PARAJET TECHNICAL ADVISORY BULLETIN

AUGUST 2020 - THROTTLE CABLE RETAINER INSTALLATION

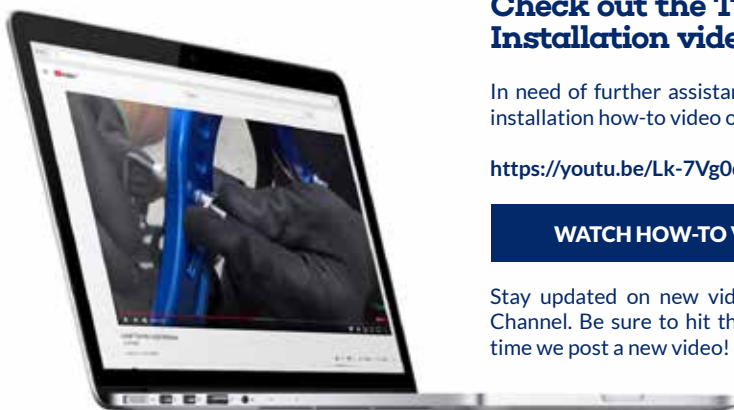
Parajet are aware of a small number of cases where the incorrect installation or wear to these retaining straps has led to slippage and increased slack. Therefore, the Velcro strap has been identified as a less effective solution and a bungee cord retaining system has been implemented.

Pilots should contact Parajet to request an upgrade kit which will be sent out free of charge. This kit should be fitted to all older Parajet models following the installation instructions detailed below in this bulletin.

18) Take hold of the throttle cable so that the loop in the bungee cord is located between your index and middle fingers.

19) Tensioning the bungee cord on both sides of the pivot arm, and exerting some pressure, pull the knot back into the brass bush.
